107 HIGH STREET, LINDFIELD, HAYWARDS HEATH, RH16 2HR

**PART VII | PROPOSED REGULARISATION
OF SCHEME**

The proposed scheme hereunder assessed is a variation of the scheme approved under DM/22/3694 and DM/22/3695, combining elements of the scheme as implemented and other elements, as yet not implemented.

COMPARISON - SITE PLAN REV A. 1:300@A3

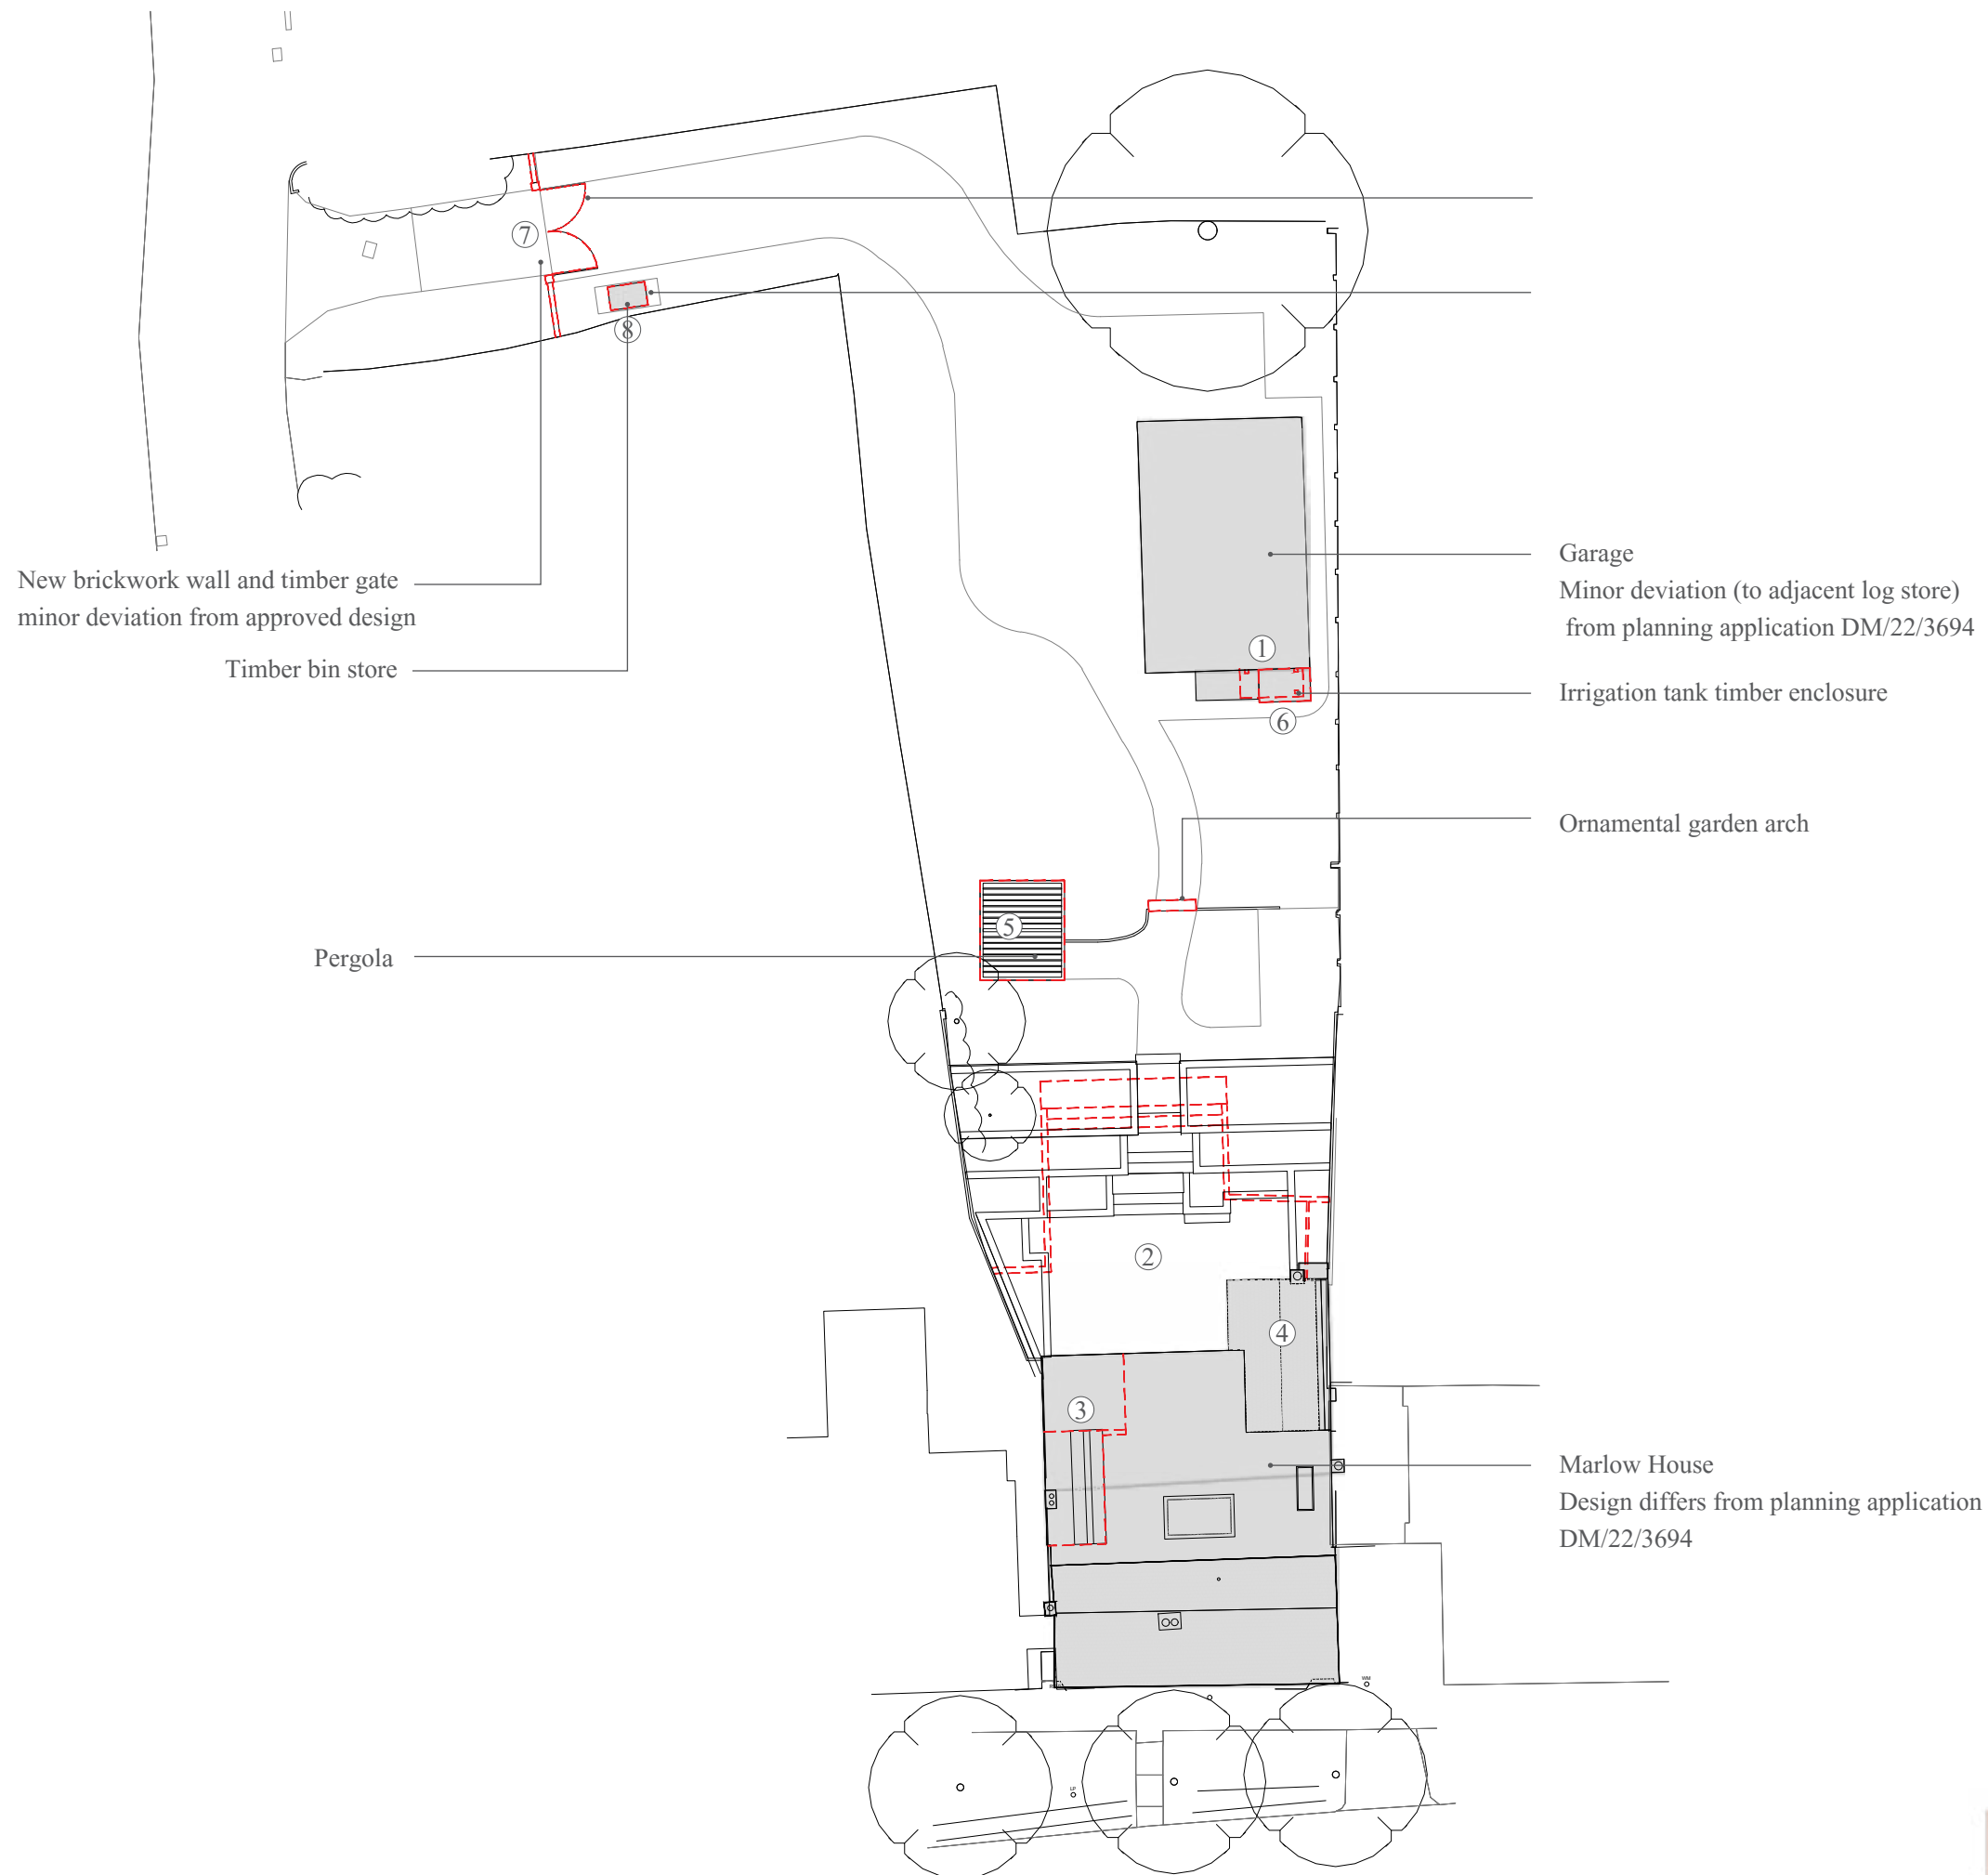
1. Garage design deviates from approved design
2. Landscape deviates from approved design
3. Rear extension spans across full width and deviates from approved design
4. Historic bake house re-constructed following its collapse during strip-out.
5. Pergola - no planning permission
6. Irrigation tank timber enclosure, no planning permission
7. Brickwork gate and timber gate deviates from approved design
8. Timber bin store, no planning permission

COMPARISON - GROUND FLOOR PLAN REV A. 1:100@A3

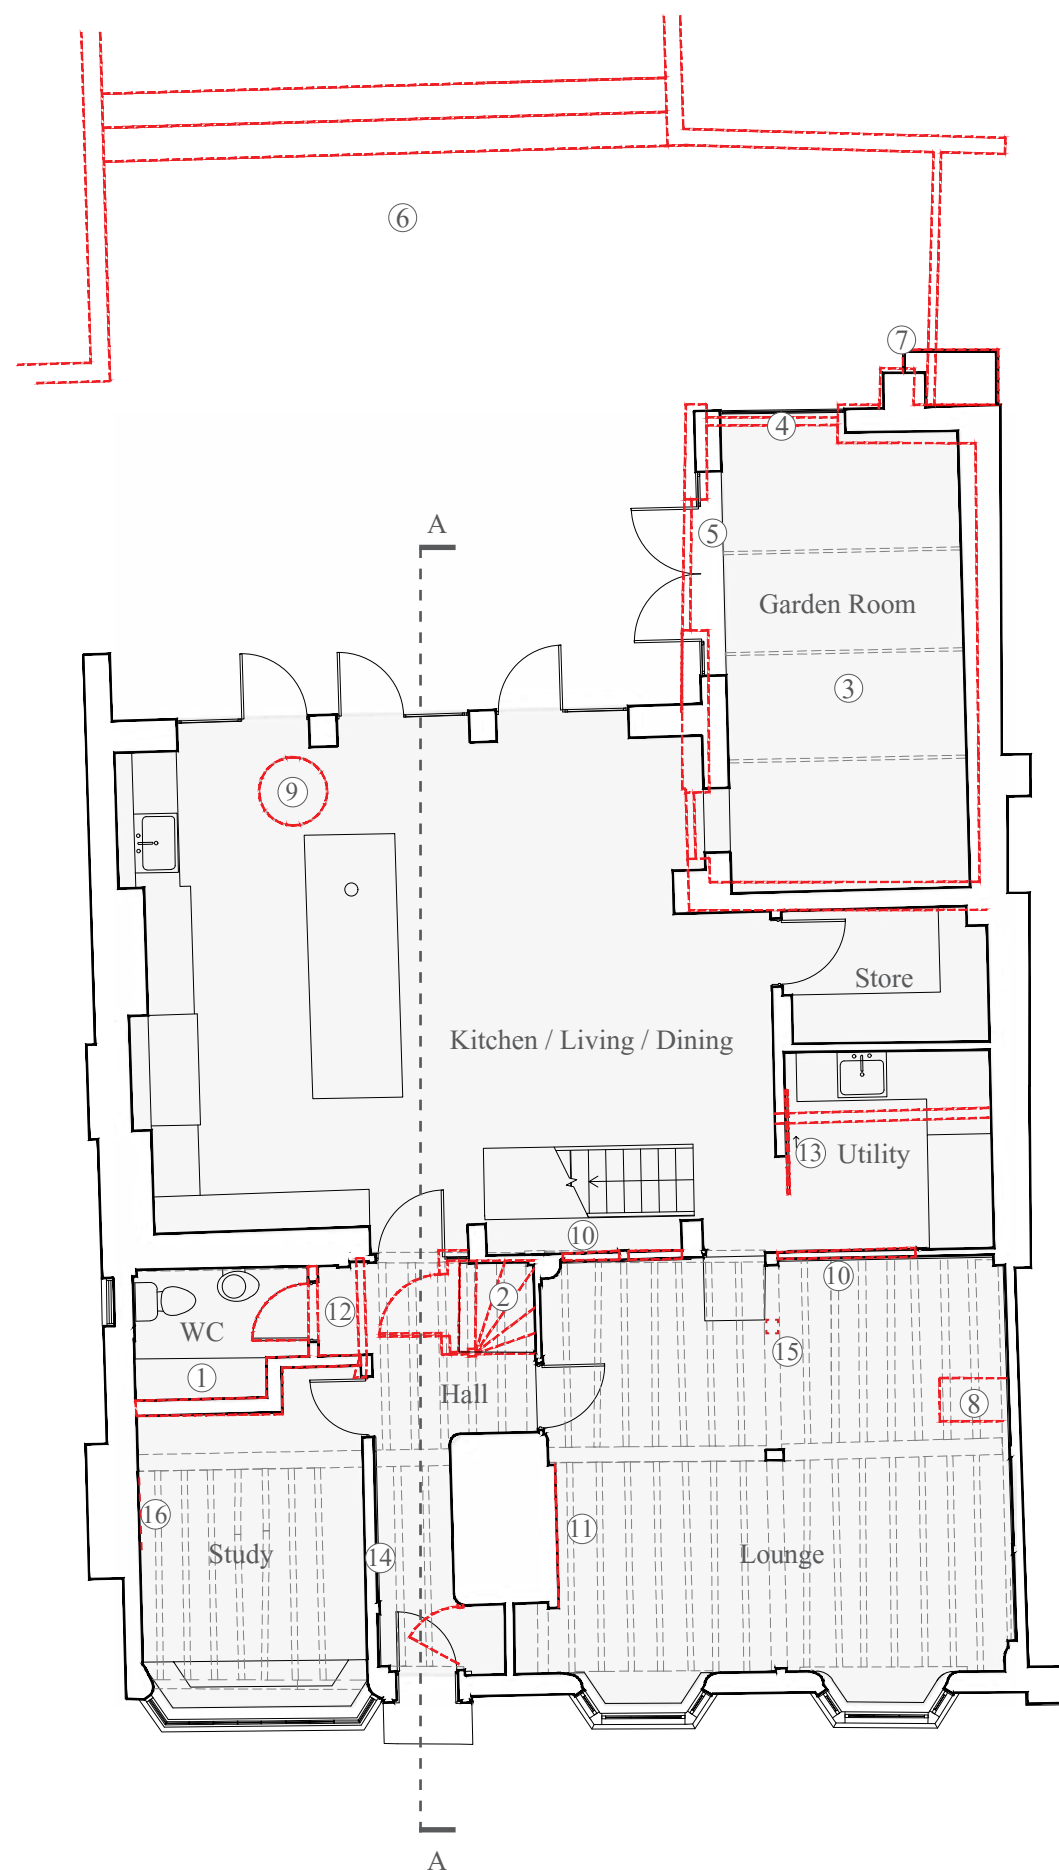
1. Change of layout - WC added
2. Existing staircase (linking ground, first and second floor) removed
3. Historic bake house re-constructed following its collapse during strip-out.

4. Window of different design
5. Doors of different design
6. Landscape of different design
7. AC AHU louvred timber enclosure - matching timber of new extension

8. Existing chimney stack removed
9. Glass covering of historic well (discovered during construction works)
10. Removal of 1990s internal casement windows to box framing of 15th century west wall, openings filled in with timber stud framing, wood wool boards and lime plaster

11. Re-facing of main chimney breast to ground and first floor rooms in reclaimed brick in hydraulic lime mortar incorporating new hearths
12. Removal of timber stud wall with stone veneered nogging at ground level to create a reveal / recessed entrance to WC is proposed as implemented.

13. Sliding door partition to wine cellar / utility room,
14. Timber cladding to evoke timber framing to main entrance passage on walls
15. Historic door jamb removed

16. Electric fireplace installed in the existing fireplace opening

COMPARISON - FIRST FLOOR PLAN REV A. 1:100@A3

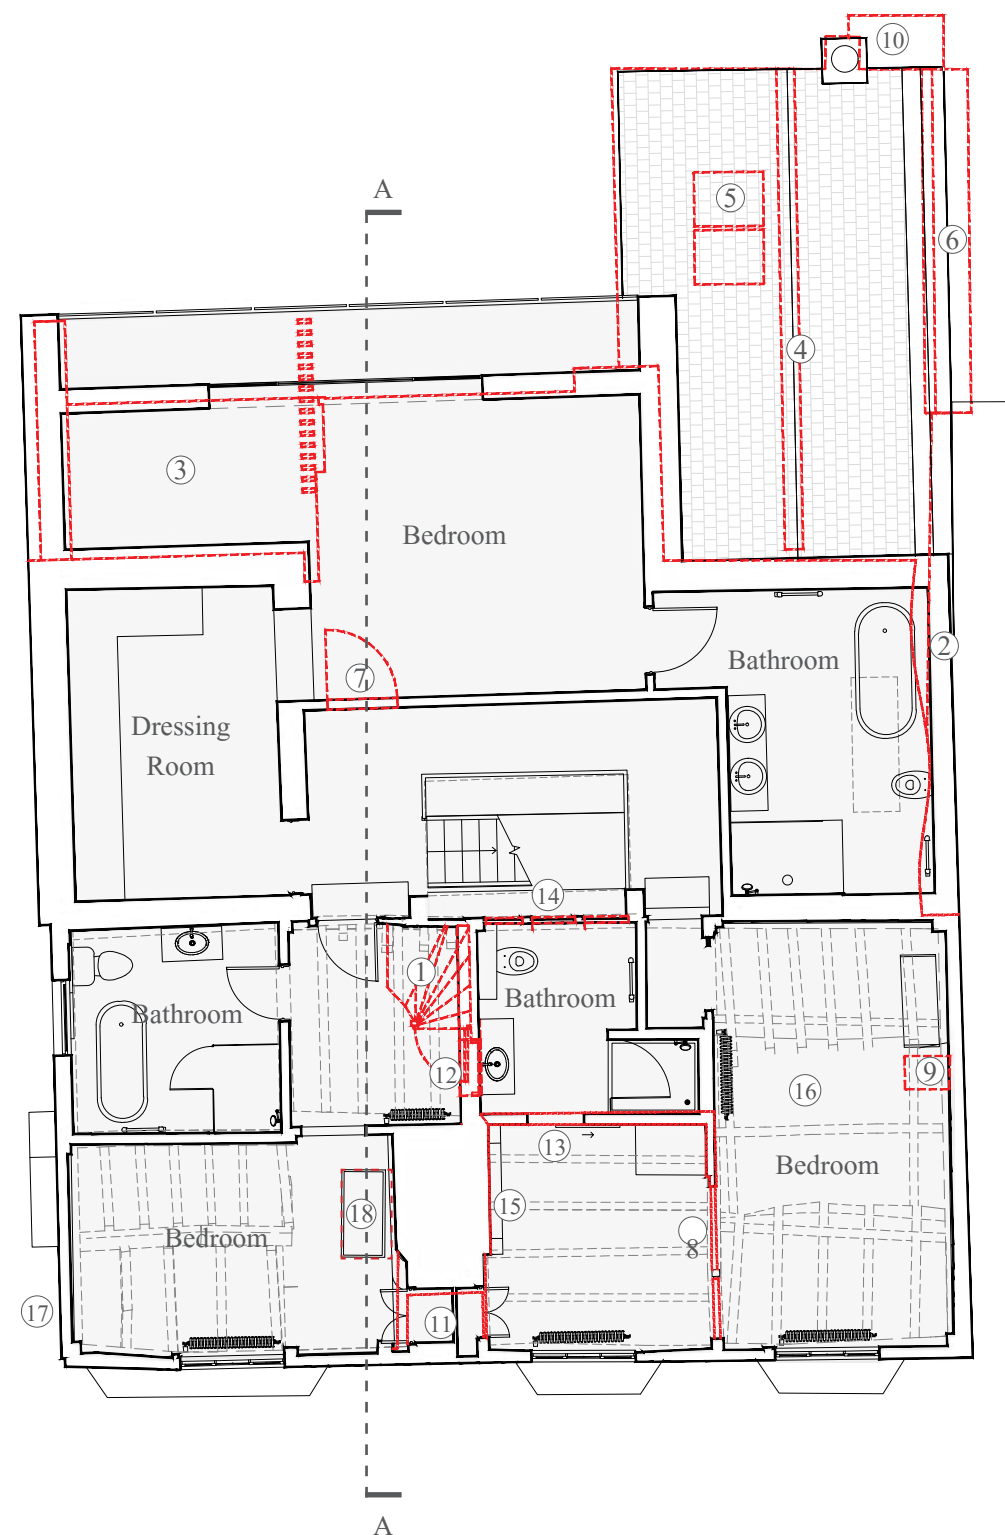
1. Existing joinery and staircase (linking ground, first and second floor) removed
2. Flat roof extension above bathroom
3. Rear extension extended - spanning full width, concealing the historic gable

4. Historic bake house re-constructed following its collapse during strip-out.
5. Rooflights omitted (2no)
6. Gutter design deviates from approved- parapet wall and secret gutter

7. Existing door opening blocked up
8. Modern plaster infill panel removed, original oak frame retained
9. Existing chimney stack removed
10. AC AHU louvred timber enclosure - matching timber of new extension

11. Fitted back to back wardrobe with new joinery installed within the existing niche
12. Existing doorway blocked up, additional wall build-up
13. New partition and sliding door to create bathroom

14. Removal of 1990s internal casement windows to box framing of 15th century west wall, openings filled in with timber stud framing, wood wool boards and lime plaster

15. Re-facing of main chimney breast to ground and first floor rooms in reclaimed brick in hydraulic lime mortar incorporating new hearths
16. Overlaid seasoned oak flooring to first floor rooms overlaying original floorboards (retained in situ)

17. Timber weatherboarding not continued to ground level*
18. Attic access hatch

COMPARISON - SECOND FLOOR PLAN REV A. 1:100@A3

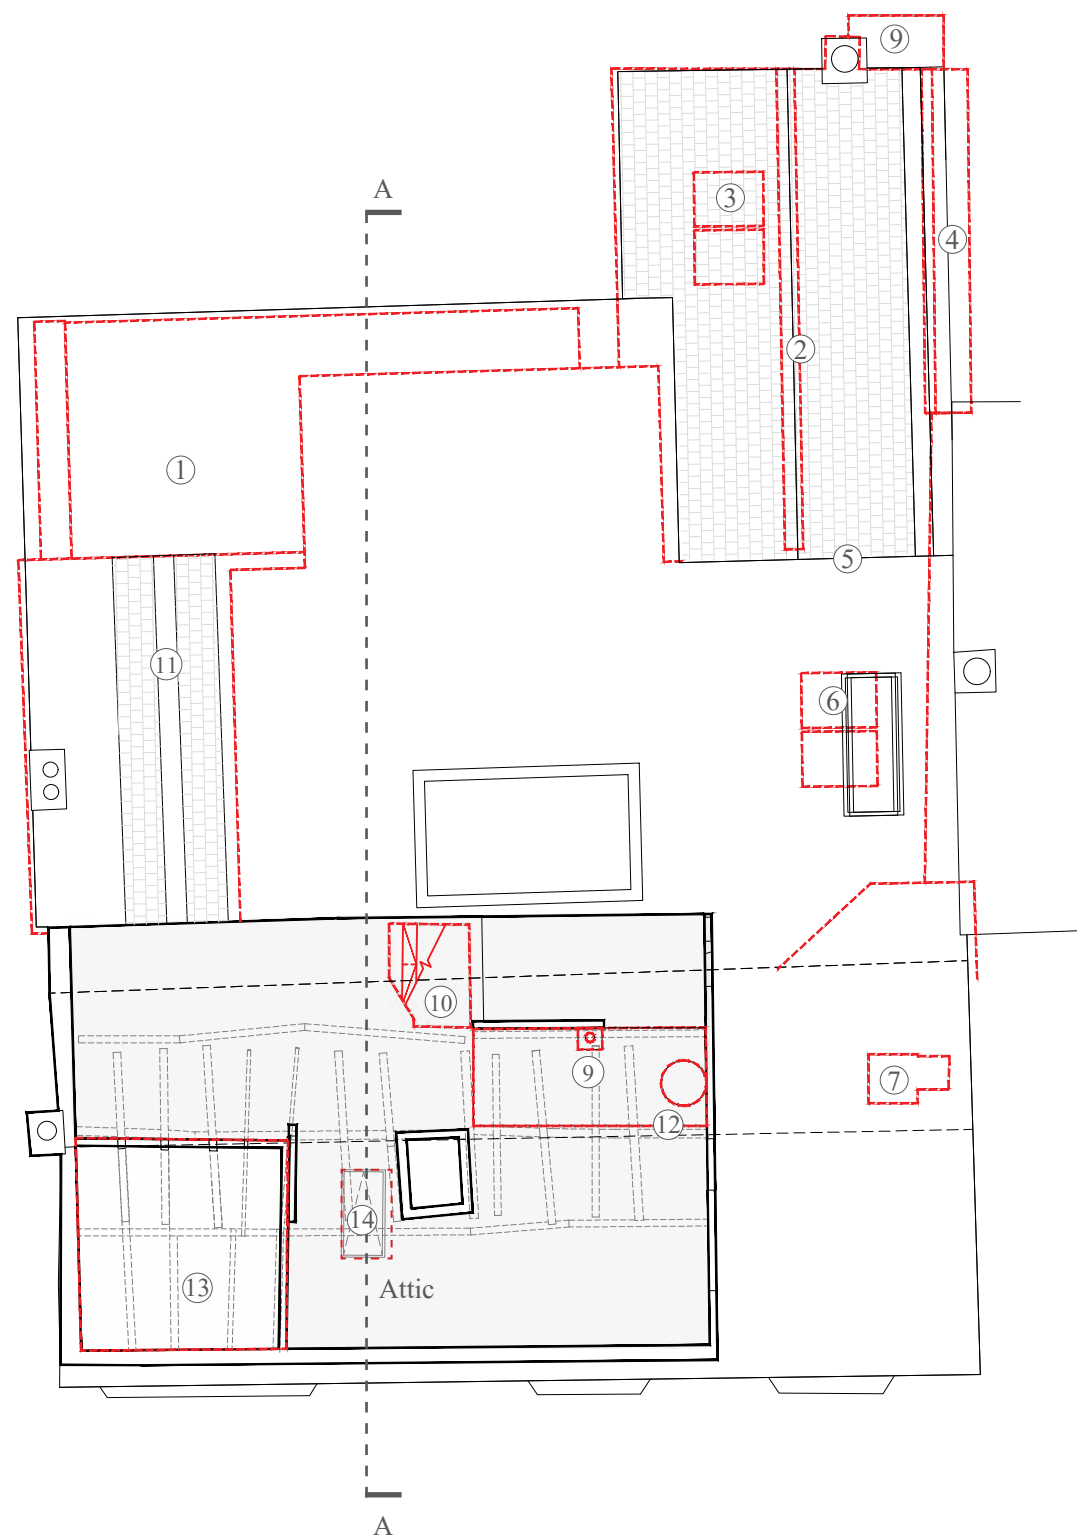
1. Rear extension extended - spanning full width, concealing the historic gable
2. Historic bake house re-constructed following its collapse during strip-out.
3. Rooflights omitted (2no)
4. Gutter design deviates from approved- parapet wall and secret gutter
5. No step between roof planes
6. Single rooflight instead of two
7. Existing chimney removed
8. AC AHU louvred timber enclosure - matching timber of new extension
9. Boiler and flue installed
10. Existing staircase (linking ground, first and second floor) removed
11. Historic gable partially visible above new flat roof
12. Water tank installed
13. Vaulted ceiling above bedroom
14. Attic access hatch
